Proposal for the 08 series of amendments to UN Regulation No. 16 (Safety-belts)

Submitted by the expert from Germany

The text reproduced below was prepared by the expert from Germany. It introduces amendments to Regulation No. 16 (Safety-belts). The modifications to the existing text of the UN Regulation are marked in bold for new or strikethrough for deleted characters.

Model A

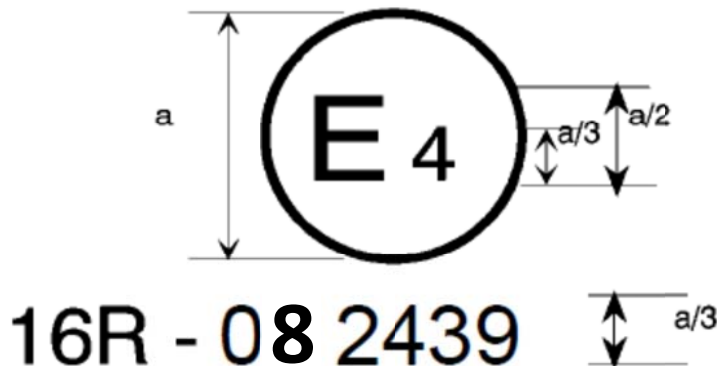
The above approval mark affixed to a vehicle shows that the vehicle type concerned has, with regard to safety-belts, been approved in the Netherlands (E 4) pursuant to Regulation No. 16. The approval number indicates that the approval was granted according to the requirements of Regulation No. 16 as amended by the 06 8 series of amendments.

Model B

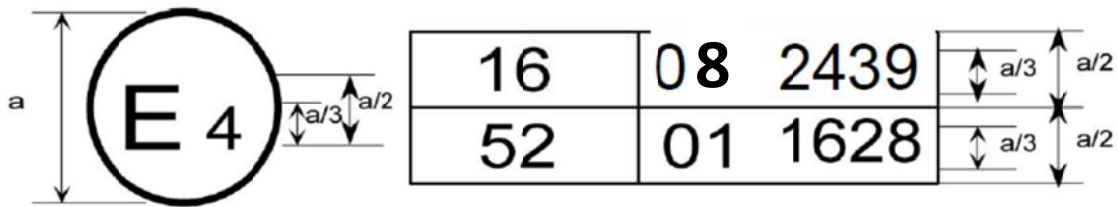
The above approval mark affixed to a vehicle shows that the vehicle type concerned has been approved in the Netherlands (E 4) pursuant to Regulations Nos. 16 and 52¹⁾. The approval numbers indicate that, at the dates when the respective approvals were given, Regulation No. 16 included the 06 8 series of amendments and Regulation No. 52 the 01 series of amendments.
